**Subject: Kern River No. 1 Hydroelectric Project, FERC Project No. 1930-090;  
Updated Study Report Response to Public Comments**

**Attachment A:  
SCE's Response to Public Comments  
on the Updated Study Report**

**Map 1b**  
**Location of Recreation Survey Sites**

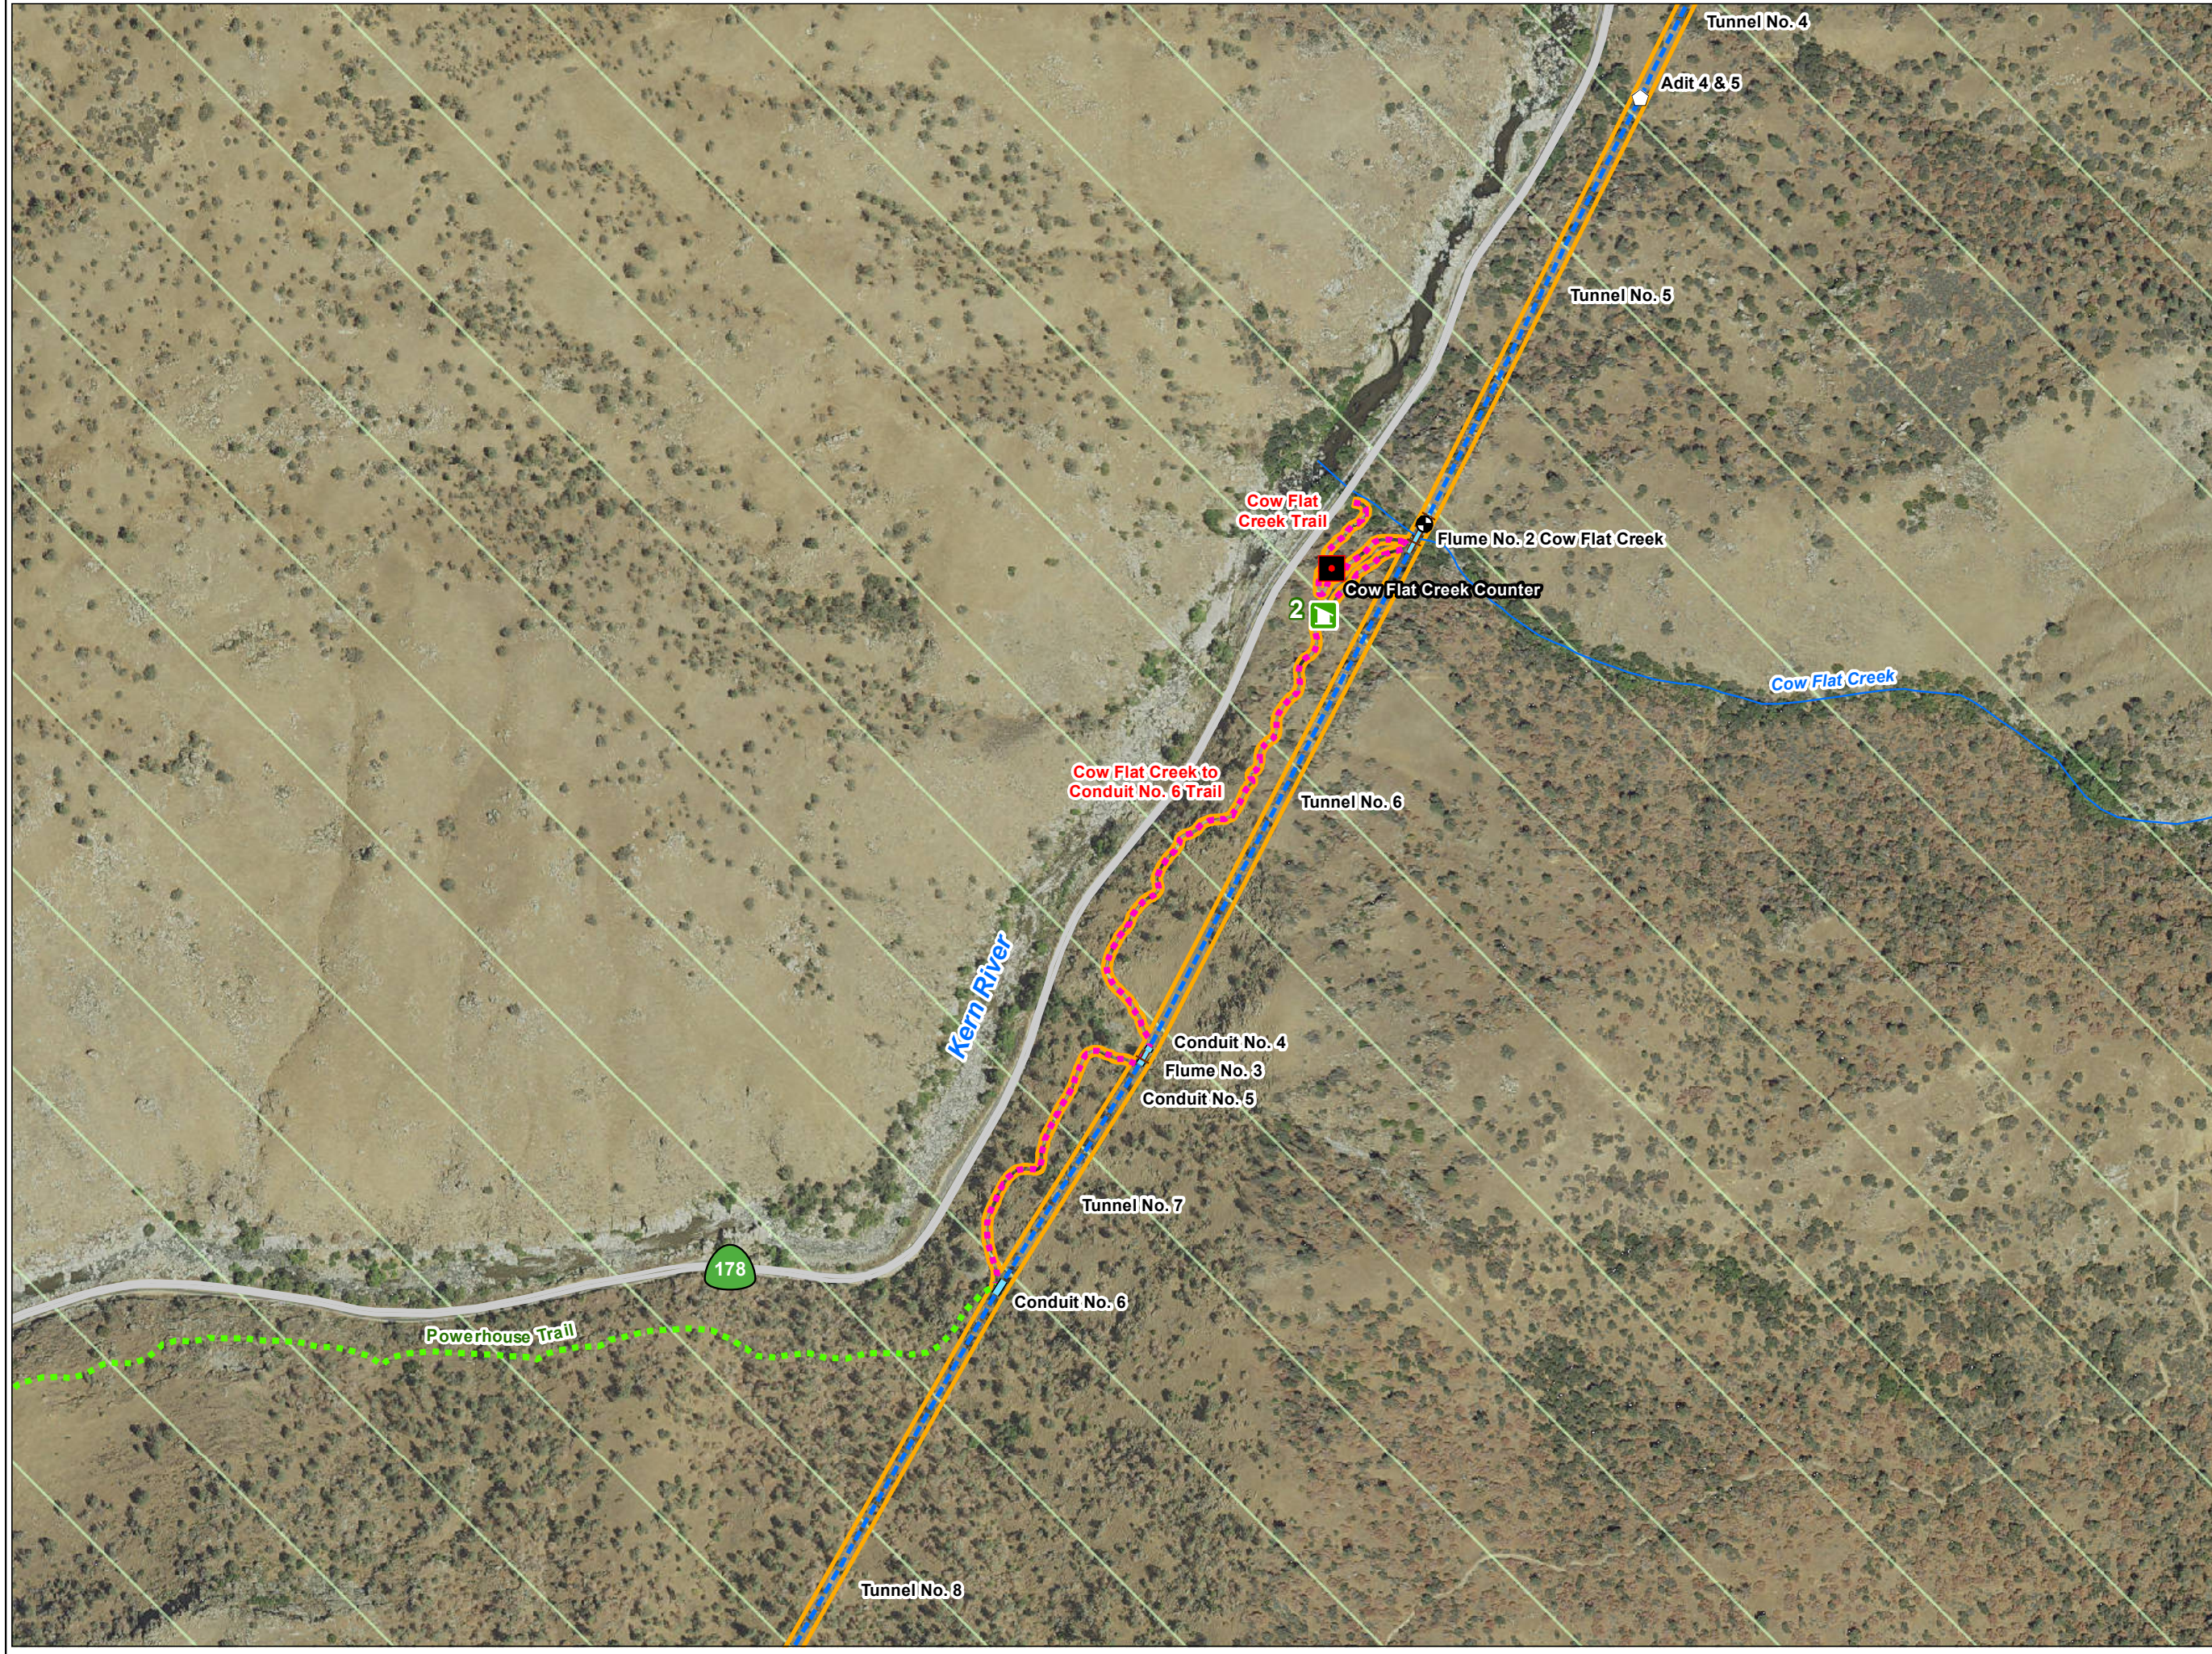
**SCE's Response:** SCE does not propose adopting this study modification. The REC 2 study was conducted in accordance with the FERC-approved study plan. In addition, the REC 2 TM presents the raw data collected from TRAFx counters in addition to providing site-specific interpretation of that data. Figures 5-3 through 5-7 in the REC 2 TM indicate the TRAFx counts for each trail over a period of more than one year (November 15, 2024, to November 23, 2025) without interpretation (i.e., raw data). Specific to the 0.13-mile Cow Flat Creek Trail that runs directly uphill from the shoulder of State Route (SR) 178 to the KR1 flowline (refer to Map 1c), the narrative states:

**Figure 1.** Thumbnail from Map 3-1.

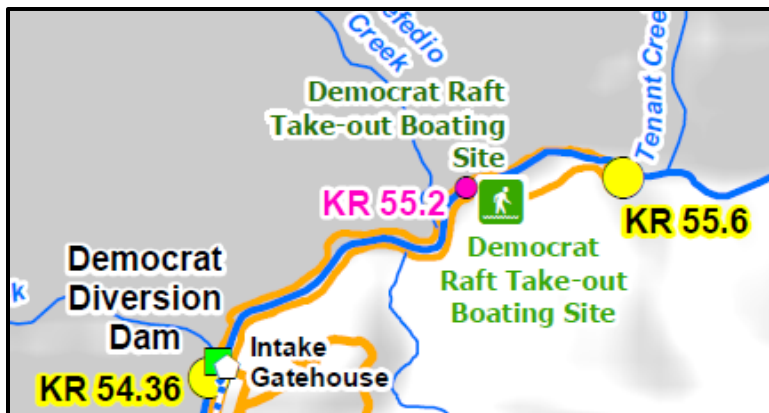
For the purposes of this comment, methylation is defined as the process by which anaerobic bacteria converts mercury to methylmercury.<sup>3</sup> Demethylation is the process by which methylmercury is transformed back into inorganic mercury.<sup>4</sup> Numerous studies have identified anaerobic aquatic sediments as “hot spots” for methylation.<sup>5</sup> Riparian areas too may harbor methylation.<sup>6</sup> The simple presence of 29 fish exhibiting bioaccumulation of methylmercury in the impoundment does not provide any data as to where the methylmercury came from. AQ-2 presents data regarding dissolved oxygen (DO) in the river upstream and downstream from the Democrat Dam – presumably the source for the assertion that anaerobic conditions are not present in the project area. Notably, however, samples were not taken in the impoundment itself, but rather only at KR 54-36 (between Democrat Dam and Instream Flow Release) and KR 55.2 (Democrat raft takeout). The distance between these samples is 0.8 miles and they “bookend” the entire impoundment (Figure 1).

methylation often occurs) which may coexist with aeriated waters if the water is not turbulent enough to disturb the sediments. Additionally, “Anaerobic sediments are more likely to exist where accumulations of organic material and fine-grained sediments”<sup>8</sup> such as riparian areas similar to those found in the area of the Democrat impoundment.

Absent sediment sampling, we have no data as to whether conditions in the project area are suitable for methylation or whether methylation has occurred. During internal FS discussions of the issue of methylation, it was suggested that fish at Democrat Dam may be absorbing methylmercury produced upstream from the project area (e.g., Isabella Lake). To be sure, bioaccumulation can occur as result of direct contact with methylmercury. And methylmercury is readily soluble.<sup>9</sup> So, the question is whether methylmercury produced upstream may be present. While demethylation can be the result of biotic or abiotic processes, the most common abiotic pathway appears to be photodegradation.<sup>10</sup> The river upstream from the Democrat Dam impoundment is noted for whitewater conditions (indeed it is favored as such by recreationists). It seems at least plausible that significant potential for photodegradation would occur in the rapids between Isabella Lake and Democrat. Absent significant mixing in the impoundment, it also seems plausible that conditions for photodegradation and demethylation there are less present. As with other aspects of the methylmercury studies reported in AQ-2 and AQ-3 there is not enough information to answer the following questions:
